E5515C-12

**S E R V I C E N O T E**

E5515C Wireless Communications Test Set (8960 Series)

Serial Numbers: MY48360101 to MY48363048.....and E5515C with an upgraded Rear Panel (E5515-60537)

Figure 1

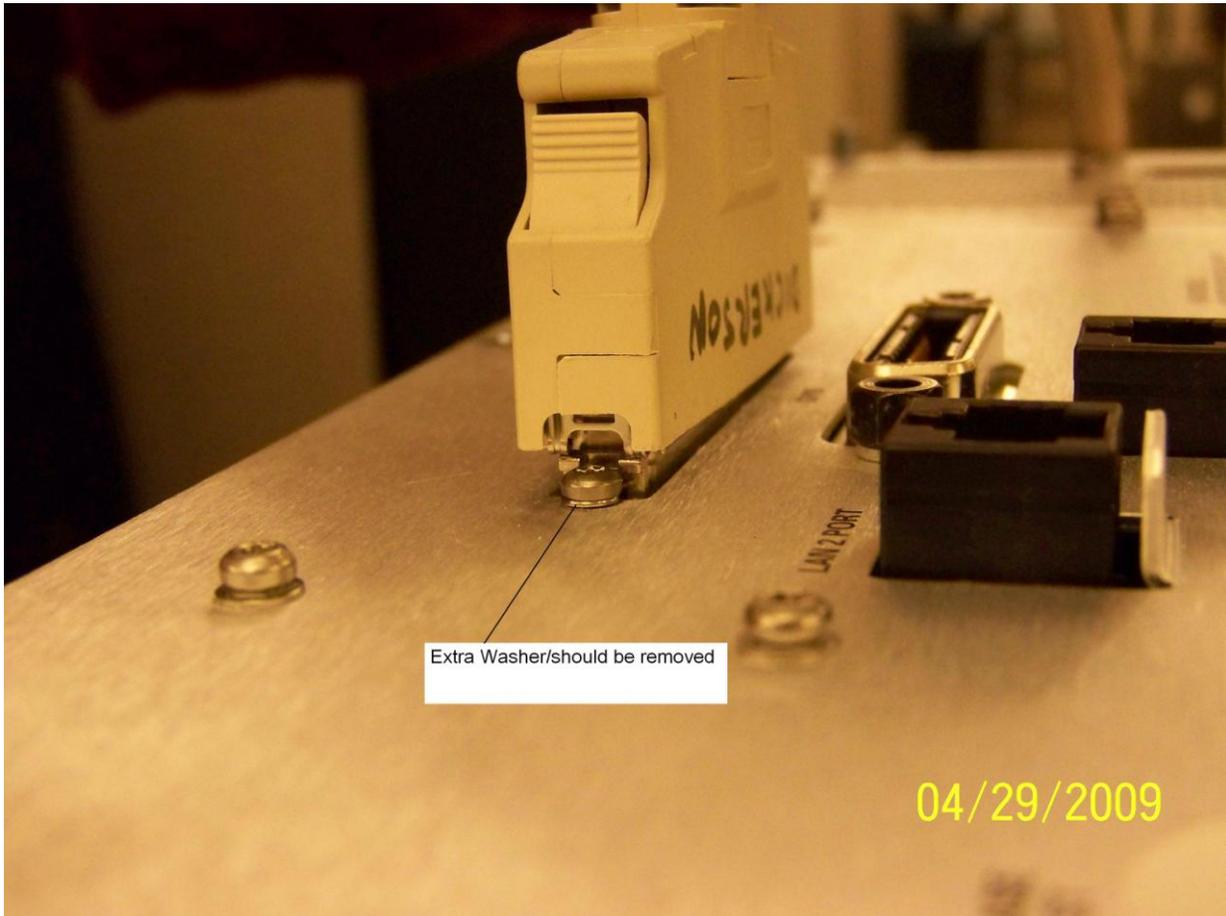
Fail to mate the cable on the rear panel “digital bus” connector, the failure is due to an extra washer(x2) to be added on rear panel, it causes the connector can not settle on the right position. see picture below:

Check the instruments which are in SSU for service and remove the washer(x2) if it is found. or guide the user to perform the modification by qualified person.

1. Remove the outer cover and top cover for the 8960
2. Remove the Host Processor and Protocol Processor Modules
3. Loosen the two screws connecting the digital bus connector (see Figure 1).
4. Remove the two “extra washers”, then re-attach the digital connector
5. Reinstall the modules and covers.
